Product Change Notice (PCN)

Subject: Change in Marking Format on Select DFN-8 Package

Publication Date: 12/28/2023

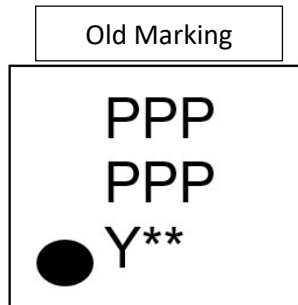
Renesas is changing the marking format for Line 3 as shown in the below diagram.

where Line 1 and 2: Product part no

Line 3: Y is last digit of the Year

** is sequential code

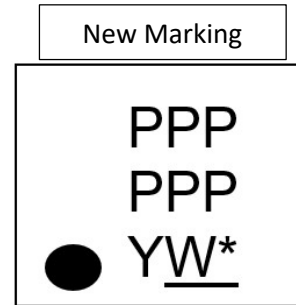
where Line 1 and 2: Product part no

Line 3: Y is last digit of the Year

W is 1 digit Workweek Code

* is sequential code

Underline to differentiate assembly house
